AGL WHOLESALE GAS LIMITED

WORKS APPROVAL APPLICATION 1003907

**RESPONSE TO SECTION 22(1) NOTICE TO SUPPLY FURTHER INFORMATION –
QUESTIONS 8 AND 12**

OPTIMISING FSRU OPERATIONS - CLOSED LOOP

Figure 3. Effect of Discharge Angle on Initial Dilution

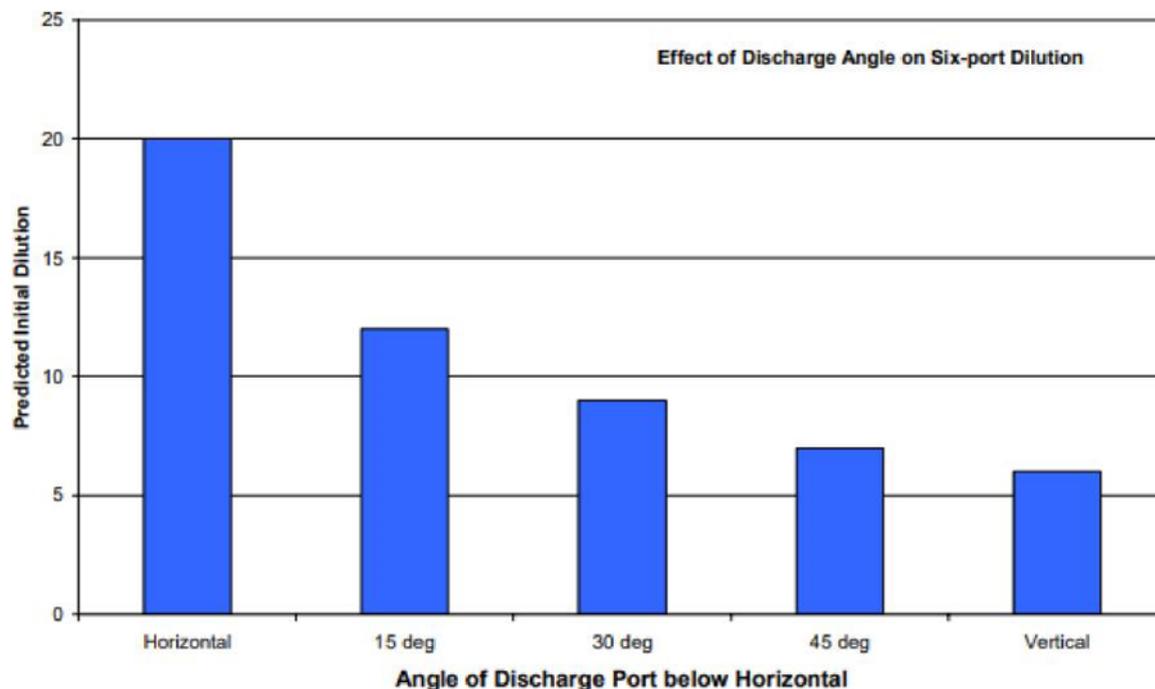
12. Clarify how the near-field model tested a range of outfall configurations to demonstrate how outlet port number, spacing and configuration were tested.

Figure 3, extracted from the 2018 Plume Report, shows the predicted initial dilution for the case of discharge from six ports of 0.45 m diameter with a total discharge of 450,000 kL/d from a fully loaded vessel at low tide. With horizontal discharge, the dilution is predicted to be 20:1. For comparison, an alternative plume model published by Cederwall (1968) predicts a similar initial dilution of 21:1. VPLUMES also predicts a dilution of 20:1.

As can be seen in Figure 3, the dilution decreases from 20:1 with horizontal discharge to 12:1 at a discharge angle of 15 degrees and to 6:1 with discharge vertically downwards. The discharge decreases as the port angle declines below horizontal (tilted down) because the length of the plume between the port and the seabed shortens as the downward angle increases, resulting in less interfacial mixing and thus lower dilution. The conclusion drawn from these predictions is that the ports should discharge horizontally to maximise dilution.
